# Access Compliance Report

## Public Rights-of-Way

### (Curb Ramps)

Intersection ID: 10015635	Main Street: HARRIS_CORNERS_PY	Cross Street: N/A	Location: S
ADA ID: 1EE48B410758	Ramp Type: Perp	Initial Pass/Fail: Fail	Overall Compliance: No
Severity Score: 12.5			
Codes/Mitigation Info/Possible Solution		Field Measurements/Component Compliance

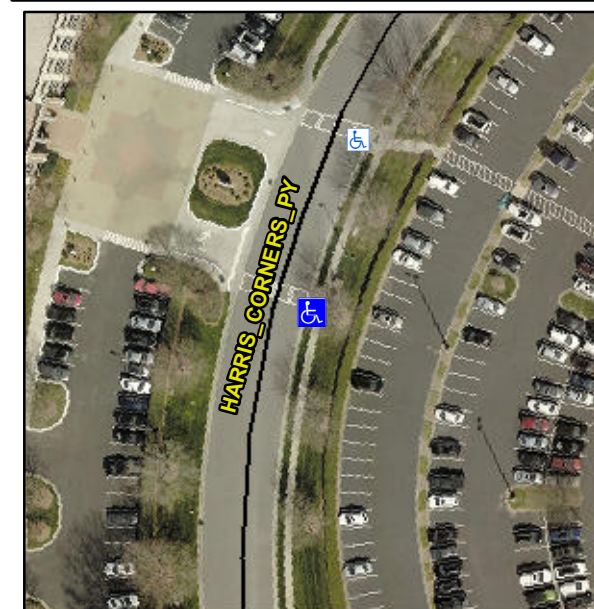
**Not Found, R304.2.2**

Compliance	Description	Data	Compliance	Description	Data
N/A	Ramp Length (in)	47.0	No	Ramp Slope (%)	9.1
Yes	Ramp Width (in)	48.0	Yes	Ramp XSlope (%)	0.9
N/A	Flare Type LT	N/A	N/A	Flare Type RT	N/A
N/A	Flare Slope LT (%)	N/A	N/A	Flare Slope RT (%)	N/A
N/A	Flare Traversable LT?	N/A	N/A	Flare Traversable RT?	N/A
N/A	Landing Length (in)	N/A	N/A	DWS Provided?	N/A
N/A	Landing Width (in)	N/A	N/A	DWS Contrast?	N/A
N/A	Landing Slope (%)	N/A	N/A	DWS Length (in)	N/A
N/A	Landing X Slope (%)	N/A	N/A	DWS Full Width?	N/A
N/A	Landing Curb? (Y/N)	N/A	N/A	DWS Offset (in)	N/A
N/A	Shared Landing?	N/A			
N/A	Gutter Ponding?	N/A	N/A	Gutter Slope (%)	N/A
N/A	Gutter Lip Ht (in)	N/A	N/A	Gutter X Slope (%)	N/A
N/A	Painted X Walk1?	Yes	N/A	Painted X Walk2?	N/A
	X Walk 1 Direction	To NW		X Walk 2 Direction	N/A
N/A	X Walk 1 Width (in)	87.5	N/A	X Walk 2 Width (in)	N/A
	X Walk 1 Slope (%)	1.2		X Walk 2 Slope (%)	N/A
	X Walk 1 X Slope (%)	0.3		X Walk 2 X Slope (%)	N/A

**Remove & Replace Entire Ramp.**
